REMARKS

RB1-041US

Annotated Sheet Showing Changes
Amended Fig. 2
(Vnom Input Added)

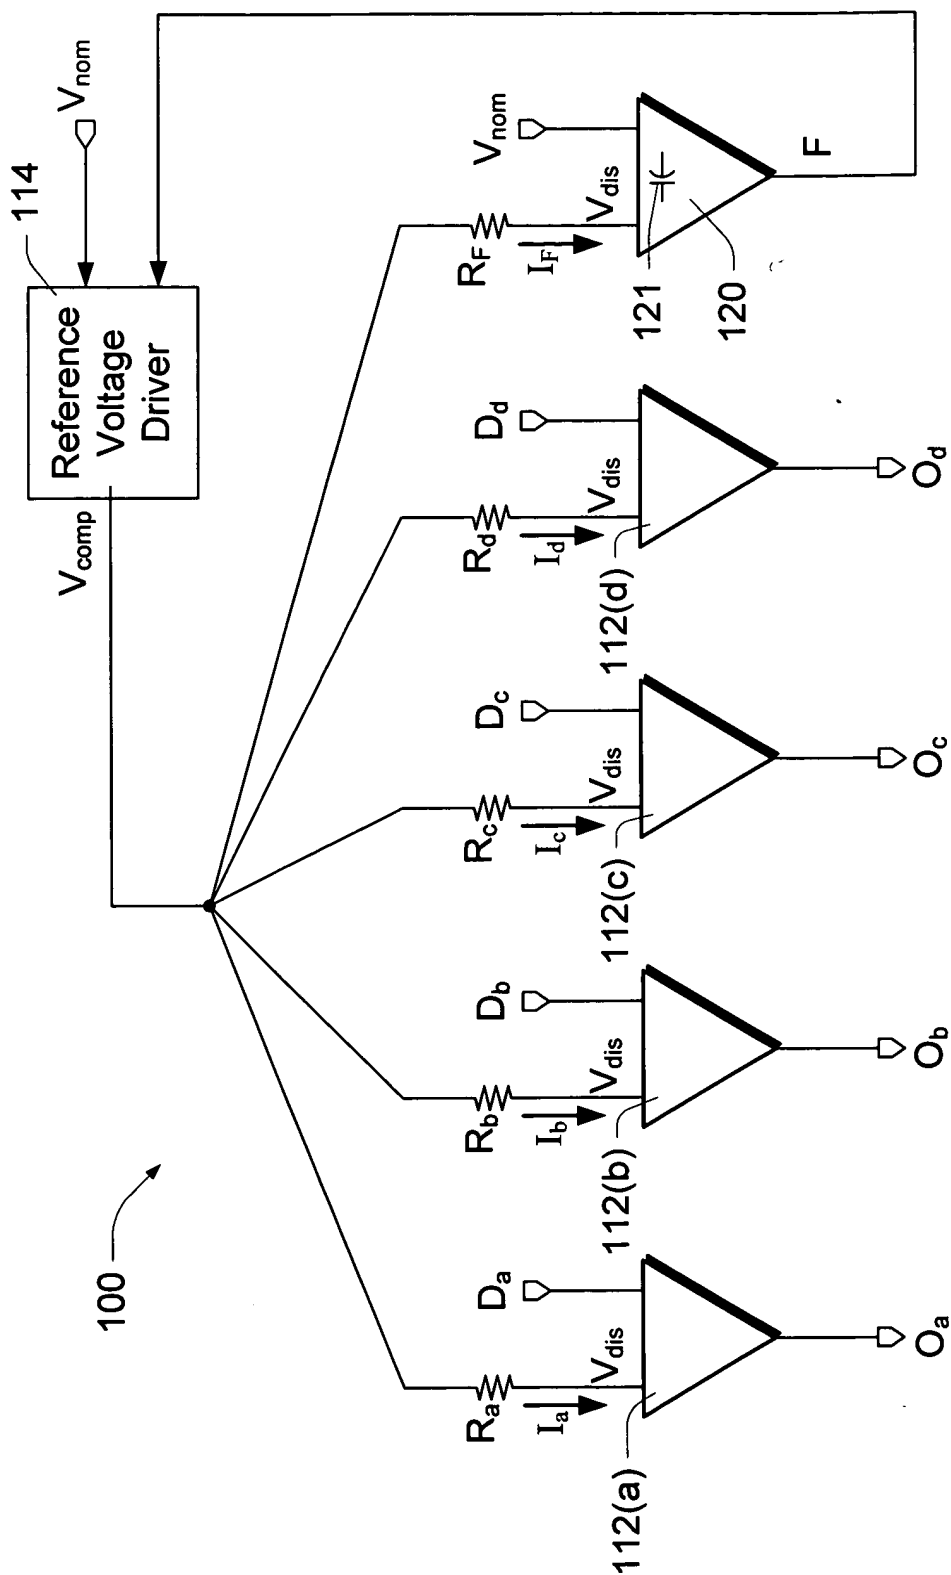
22 The current Office Action required a change to Fig. 2 with regard to element
23 114 and V_{nom} . Figure 2 has been amended so that a V_{nom} input is shown for
24 reference voltage driver 114. An “Annotated Sheet Showing Changes” is attached
25 hereto as an Appendix with the amendment (i.e., the addition) indicated in red ink.

1 Also attached hereto, and included as part of this Reply, are four (4)
2 Replacement Sheets with the change to Figure 2 shown. These four (4) Replacement
3 Sheets are suitable for use as the official formal drawings.
